Subject ▶ Change on Helical Gear

For Models ▶ 6833, 6834, 6835D

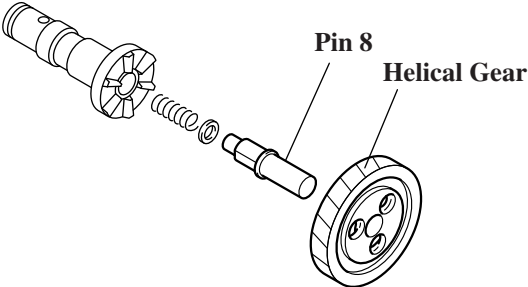
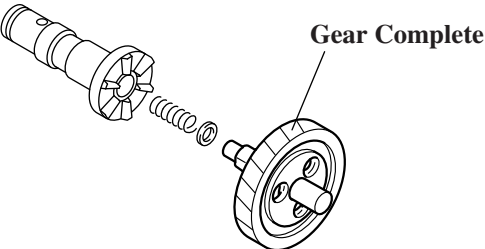
Description ▶ As illustrated below, Pin 8 has been modified and joined to Helical Gear.
And consequently, Helical Gear has been replaced by Gear Complete;

► Current	► New
6833 6835DW	Pin 8 (Part No.268032-5) Helical Gear 55 (Part No.226485-4)	Gear Complete (Part No.153275-1)
6834	Pin 8 (Part No.268032-5) Helical Gear 59 (Part No.226486-2)	Gear Complete (Part No.152622-3)
